Value Engineering Study Report
Flood Control District of Maricopa County
McMicken Dam Project

June 2015

**RE: McMicken Dam Project
Value Engineering Study Report - FINAL**

TITLE: Add box culverts to avoid levee west of US60

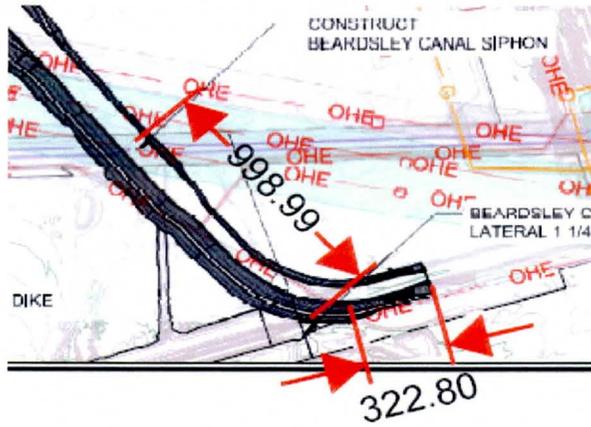
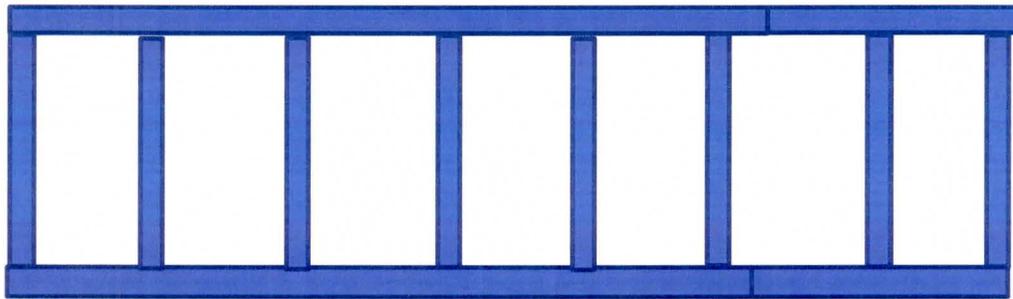
The current baseline proposal consists of a open soft-bottom trapezoidal channel with a small levee on the right bank between Beardsley Canal and the existing outflow channel to contain the 100-yr flood. The proposed alternative will replace the channel/levee segment with a box culvert to eliminate the requirement for a levee, and inspection and reporting requirements.

TITLE: Do not move principal outlet and do not protect channel

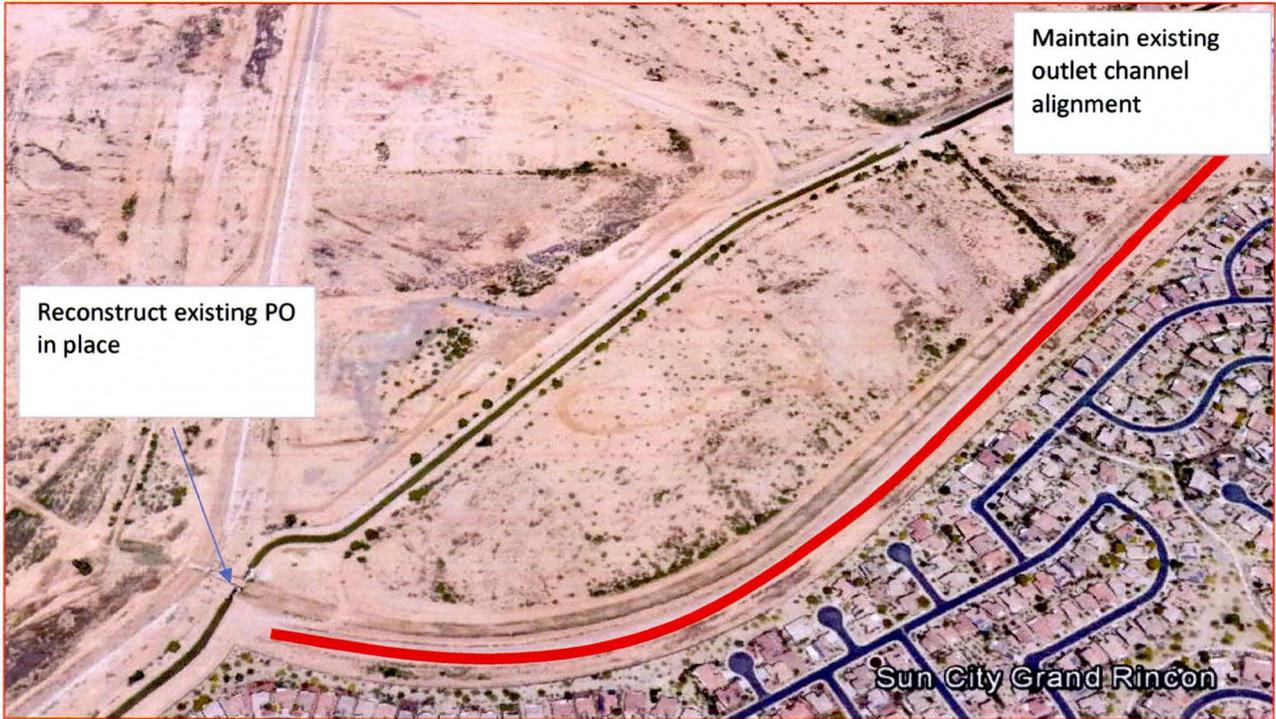
Additionally, although not part of this alternative, a stop log structure could be included to provide the capability of stopping principal outlet discharge for emergency repairs to the outlet channel.

The risk of damaging the outlet channel during an emergency spillway event may not be acceptable.

TITLE: Modify principal outlet stilling basin to include baffles

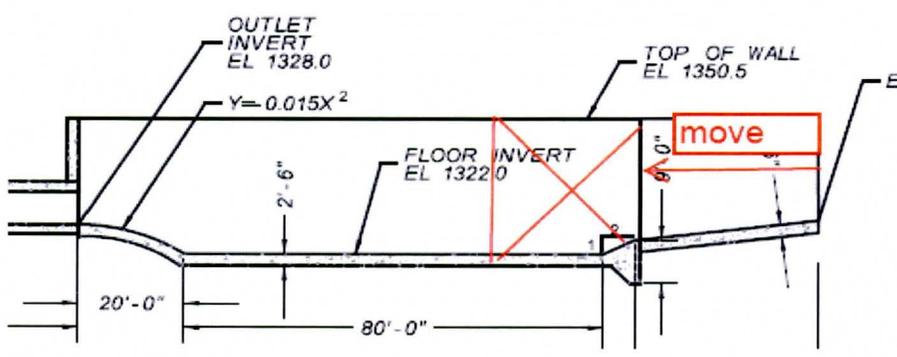
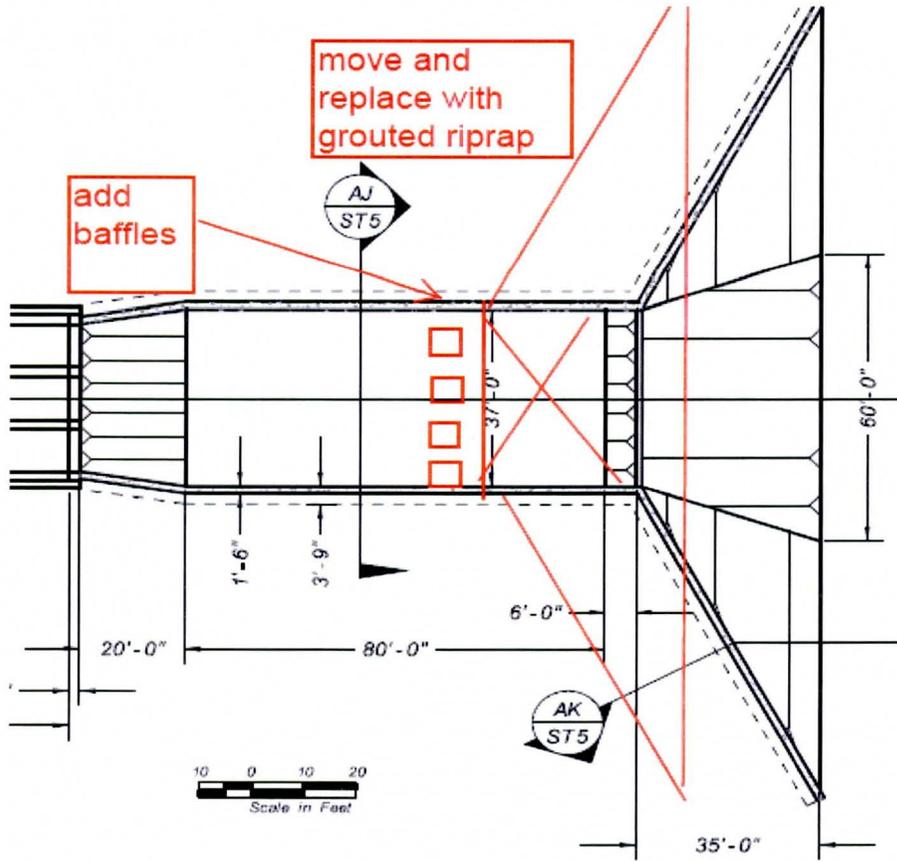
- Advantage(s)
 - Reduces length of stilling basin
 - Reduces velocities
- Disadvantage(s)
 - Limits access
- Potential savings: \$170K

TITLE: Raise embankment in lieu of Picacho Wash diversion channel

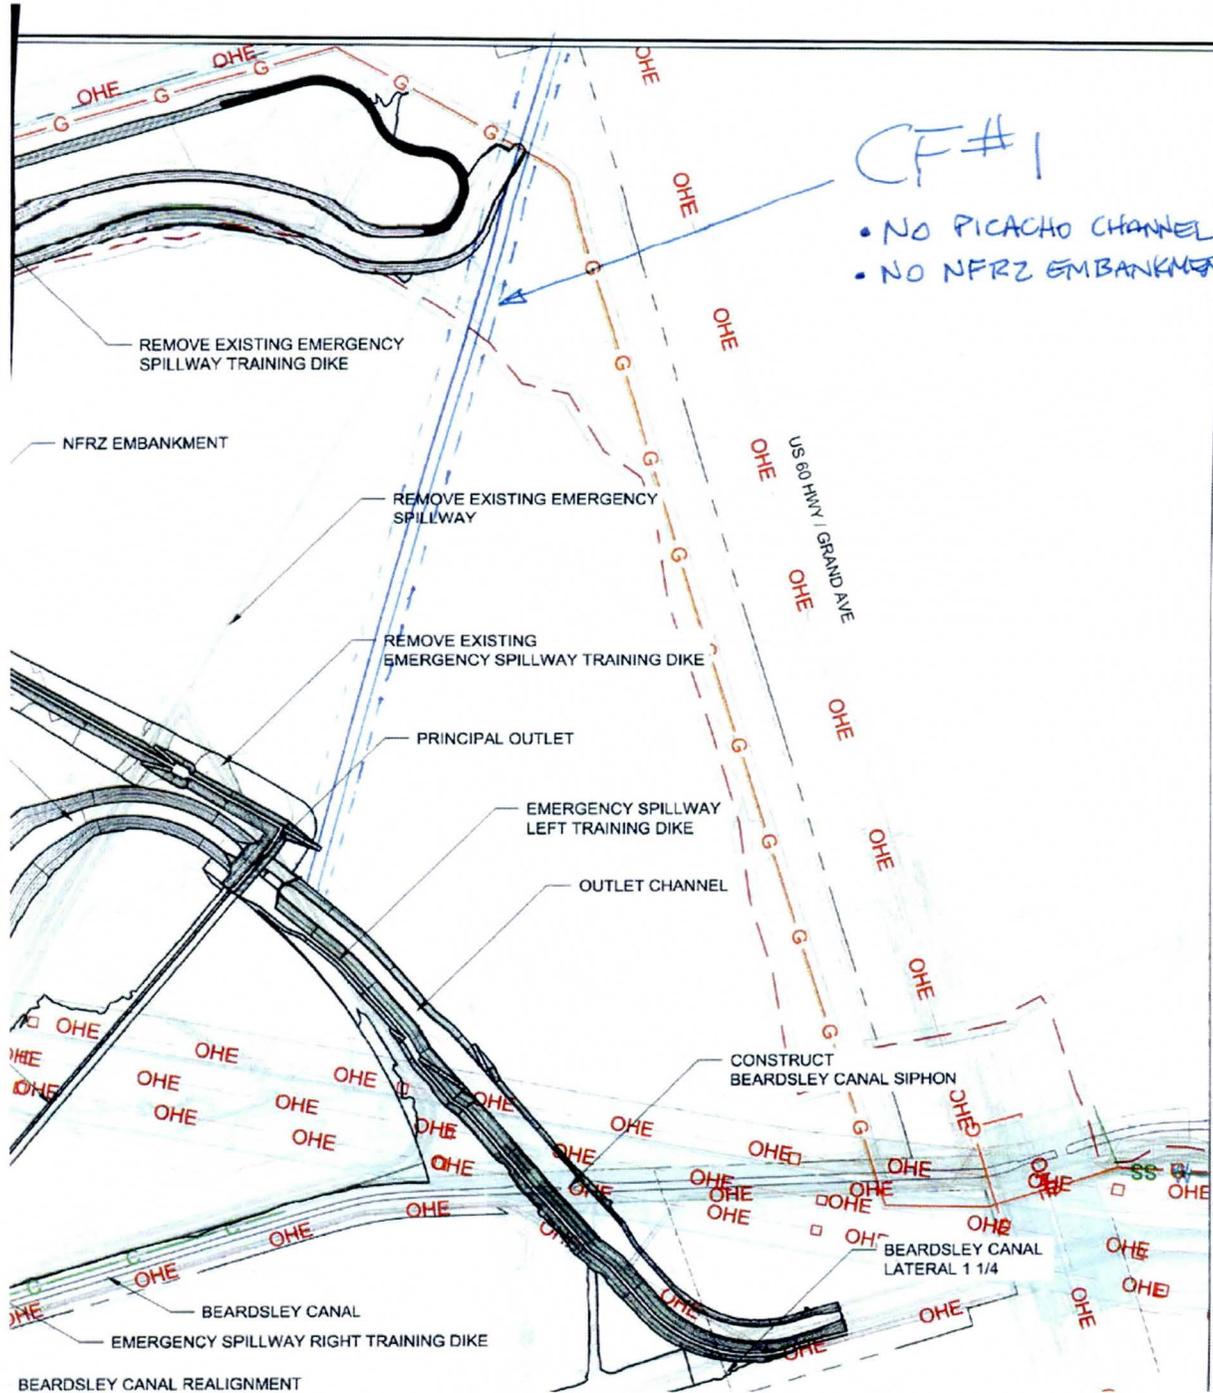
- **Advantage(s)**
 - PMF from Picacho Wash routed to McMicken Dam flood pool
- **Disadvantage(s)**
 - Reduces land available for resale (60 acres)
 - Additional embankment extends into moderate fissure risk zone
- **Potential cost: (\$1.2M)**

TITLE: Remove rock mulch from Phase II

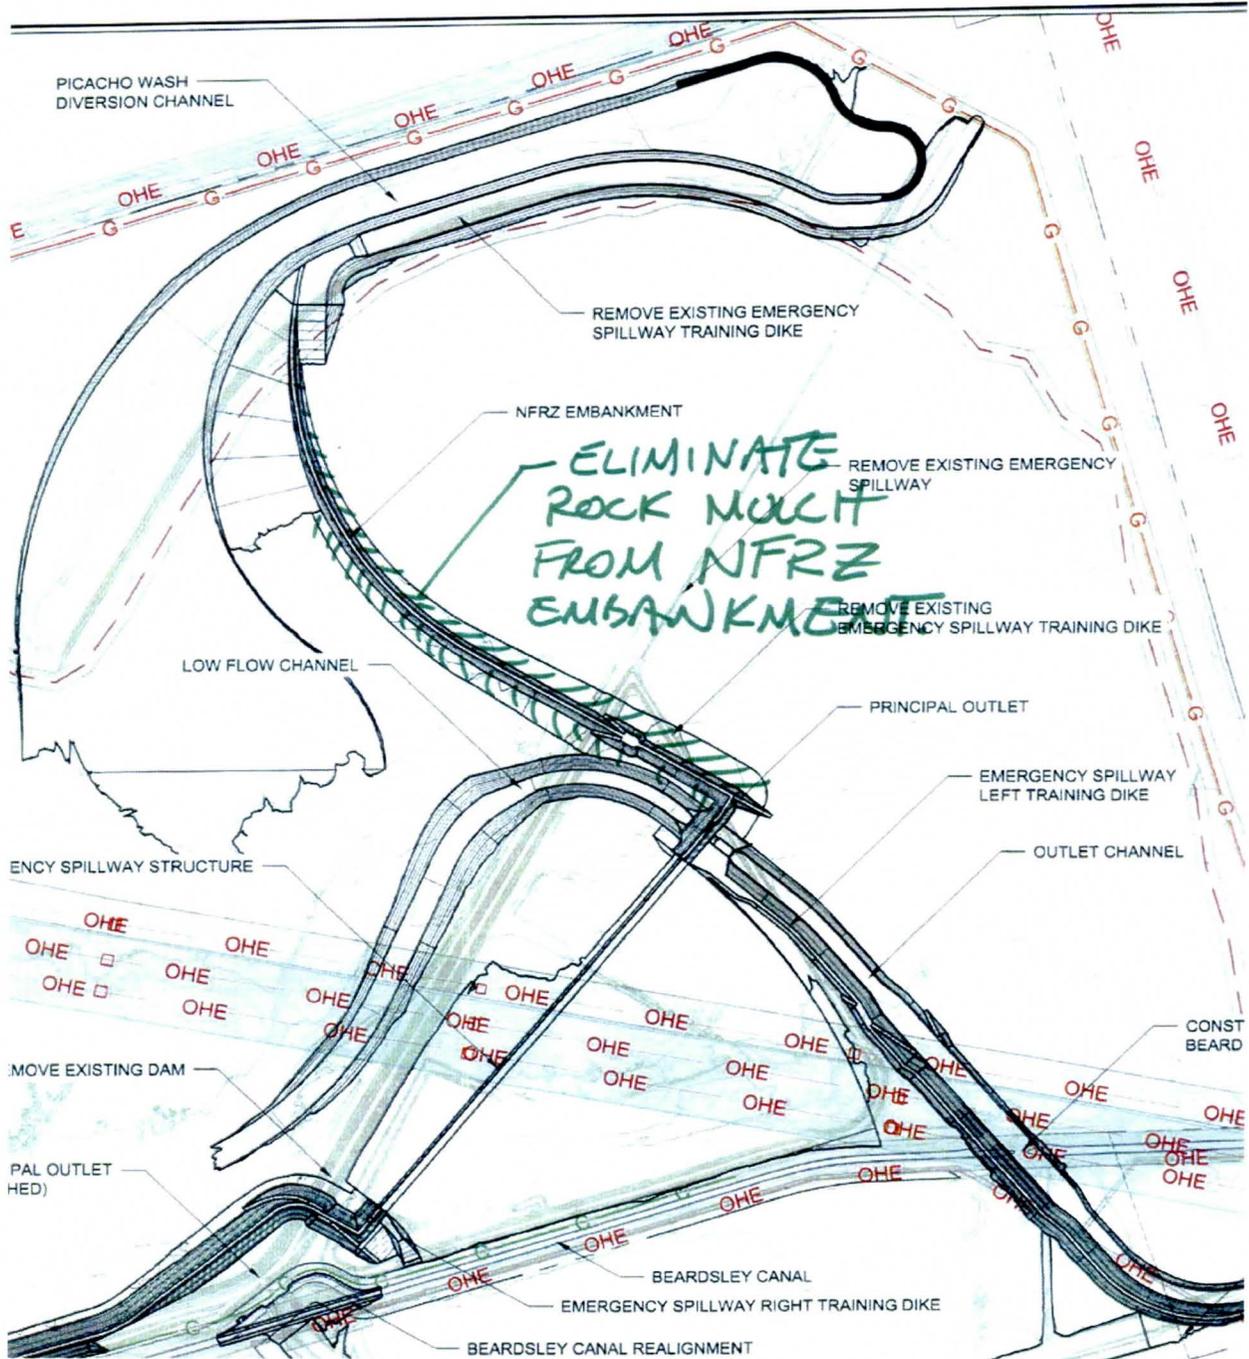
TITLE: Remove rock mulch from Phase II																			
FUNCTION: Convey 100-year Flood																			
BASELINE ASSUMPTION: The current design includes rock mulch on the upstream and downstream slope of the non-fissure risk zone (NFRZ) embankment. The purpose of the rock mulch is for erosion control, to prevent vehicle traffic on the embankment slopes and to serve as an aesthetic feature.																			
PROPOSED ALTERNATIVE: Defer the deployment of the rock mulch for 10 years and provide annual maintenance until rock mulch is deployed.																			
BENEFITS		RISKS/CHALLENGES																	
<ul style="list-style-type: none"> None apparent (except lowers Initial Cost significantly) 		<ul style="list-style-type: none"> Adds 10 years of maintenance activities associated with erosion, and potential vehicular damage to the embankment 																	
<ul style="list-style-type: none"> 		<ul style="list-style-type: none"> Loss of aesthetic component 																	
<ul style="list-style-type: none"> 		<ul style="list-style-type: none"> 																	
<ul style="list-style-type: none"> 		<ul style="list-style-type: none"> 																	
<ul style="list-style-type: none"> 		<ul style="list-style-type: none"> 																	
<ul style="list-style-type: none"> 		<ul style="list-style-type: none"> 																	
<ul style="list-style-type: none"> 		<ul style="list-style-type: none"> 																	
<ul style="list-style-type: none"> 		<ul style="list-style-type: none">

Defer implementation for 10 years and provide annual maintenance to repair erosion and/or vehicle damage.

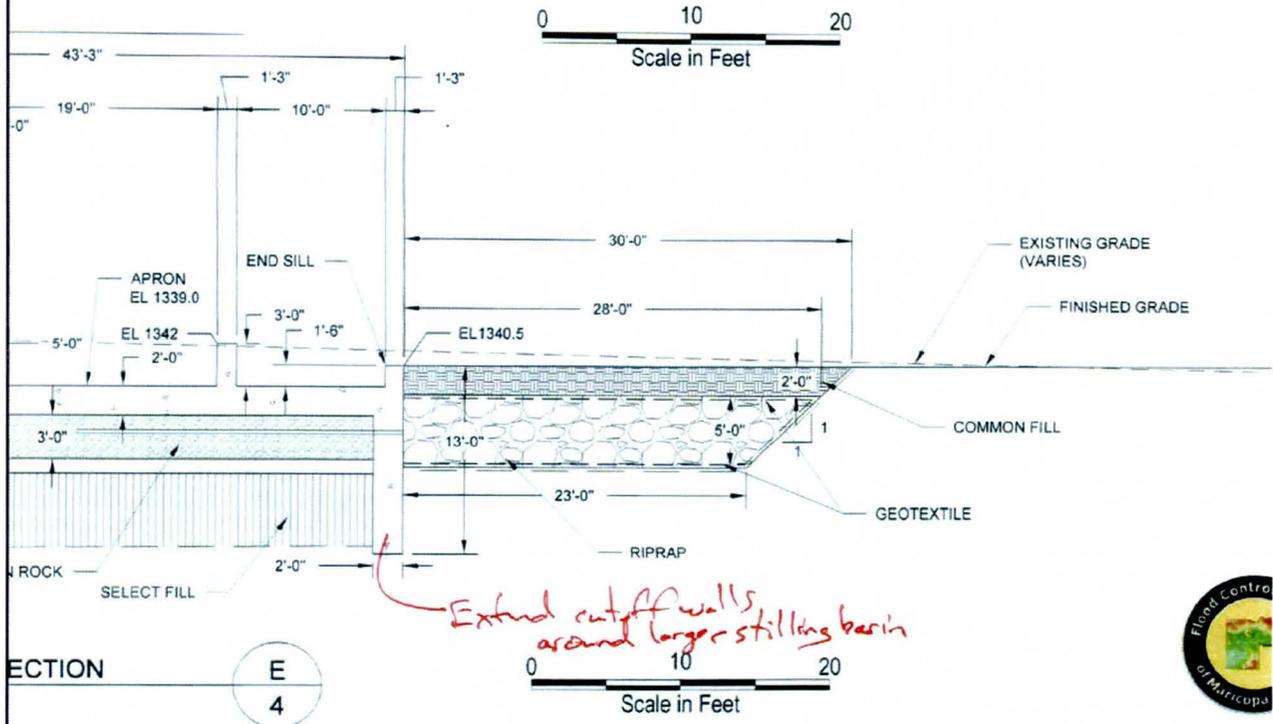
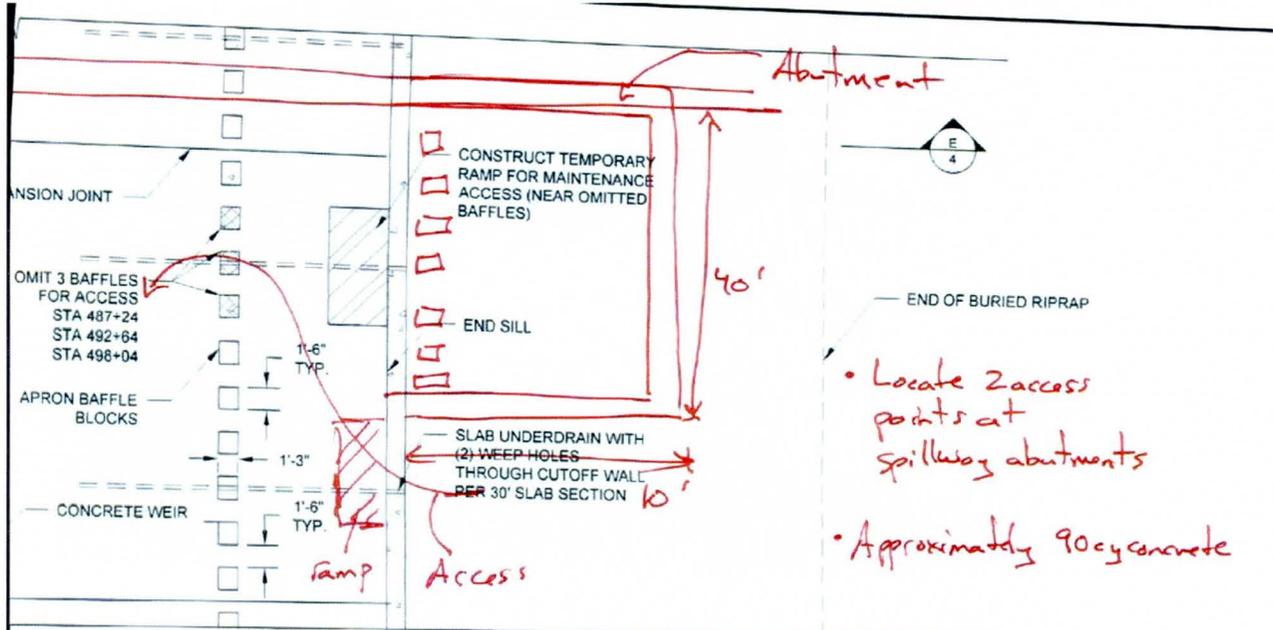
The use of a weir coefficient value of 3.3 would result in an increase to the crest elevation of the dam by approximately 0.5 ft. The intent of this alternative is to understand the proposed cost of modeling or development of justification documents to verify the use of a weir coefficient value of 3.6 versus the construction costs associated with the raised crest elevation associated with the weir coefficient of 3.3.

Emergency spillway stilling basin was designed with a continuous row of baffles, which does not provide access for maintenance crews. The proposed alternative would include the remodeling of the spillway stilling basin with a reconfigured baffle arrangement, which would allow maintenance access to the entire stilling basin area. Additionally, the remodeling would determine if the current stilling basin length is adequate, or if the stilling basin would need to be extended. Additionally, the development of a removable baffle design could be investigated.

Need to gain ADWR and FCDMC acceptance for modeling approach. Need to research availability of nationally accepted support documentation for model acceptance

CP-08: Move principal outlet north to reduce wall height

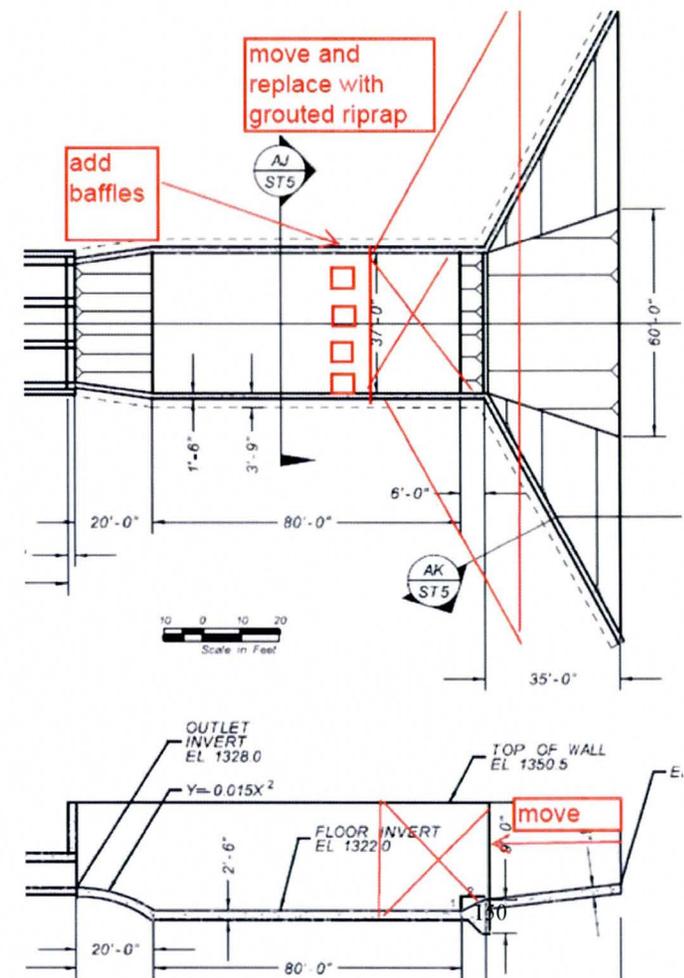
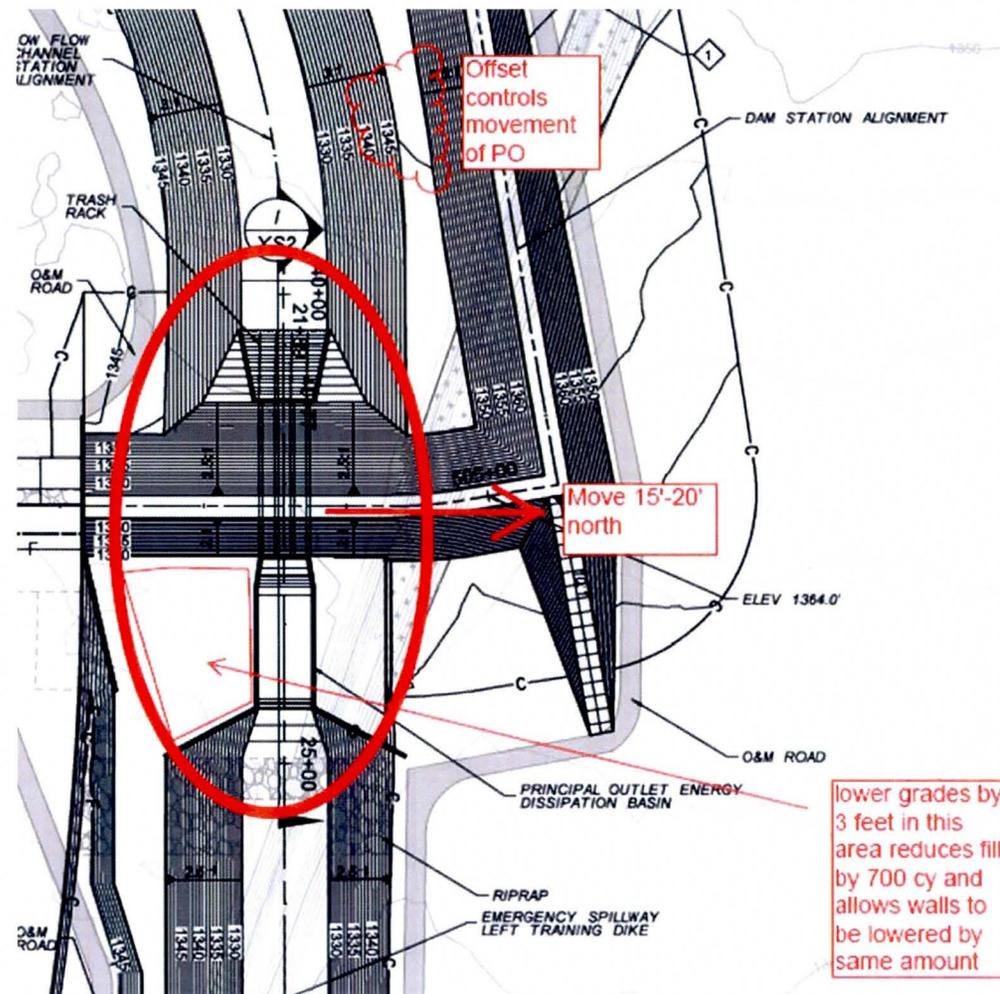
- Advantage(s)
 - Reduces concrete & fill quantities
 - Introduces buffer between spillway flows and outlet channel
- Disadvantage(s)
 - Armor at toe dam may be required
- Potential savings: \$99K
